## Credit Procedure

Figure 1. Correct Fork Lower

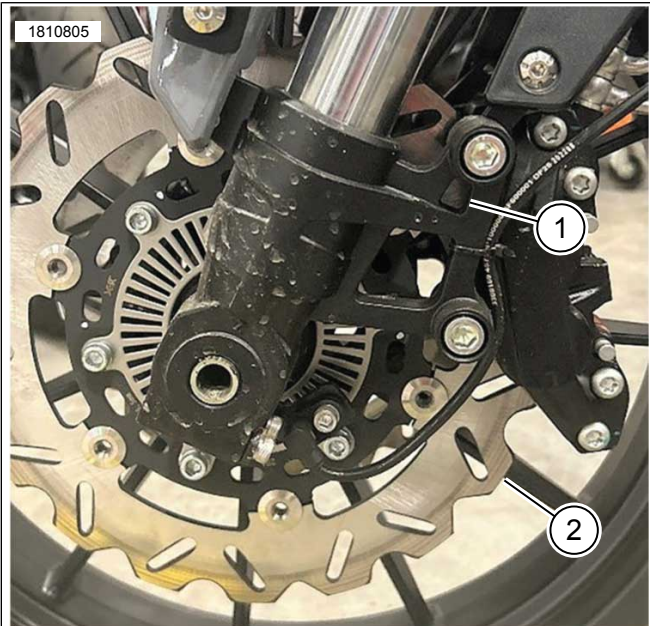
1. Gap in fork
2. Full wear on rotor

1. Gap in fork
2. Outer wear on rotor
